TECHNICAL BULLETIN

18 MAR 2020

SECTION:						
415-00						
SUBJECT/CONCERN:						
Interactive Control Display Module (ICDM) - Purple Line Flickering						
AFFECTED VEHICLE RANGE:						
MODEL:	MODEL YEAR:	VIN:	ASSEMBLY PLANT:			
Range Rover (LG)	2018-2020	343646-582956	Solihull

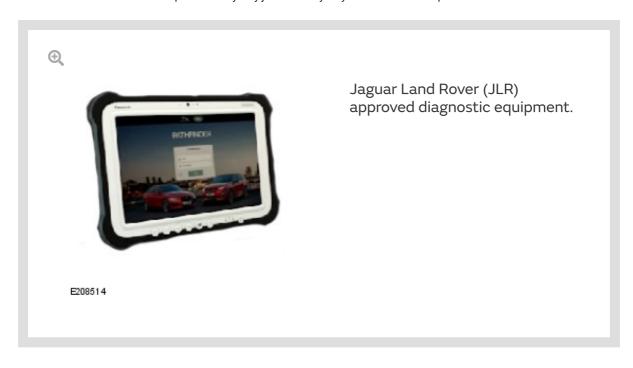
The Interactive Control Display Module (ICDM) may not be operating as expected (see the video below). A purple line can be seen flickering on the lower edge of the ICDM.

The video above shows an example of the purple line flickering on the lower edge of the <u>JCDM</u>.

Follow the instructions below.
